PRODUCT SAFETY RECALL

Remote Controller Issued September 1996

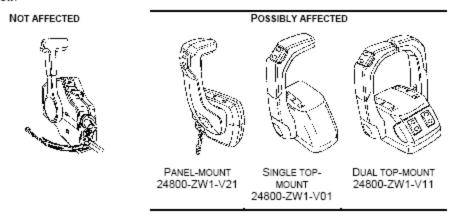
PRODUCT: Safety recall has been initiated for three of the four models of

remote controls sold by American Honda build between June 1, 1994 and September 1, 1995. The units affected do not have the

RKFW Label

PROBLEM: The failure is caused by an improperly hardened gear in the control

mechanism. This could result in the inability to reduce throttle and

shift the engine out of gear.

WHAT TO DO: If your controller matches one of the affected controllers contact a

servicing Honda marine dealer to have your controller inspected. To find the nearest Honda dealer you may check our dealer locator on our web site: www.honda-marine.com or call toll free 1-888-
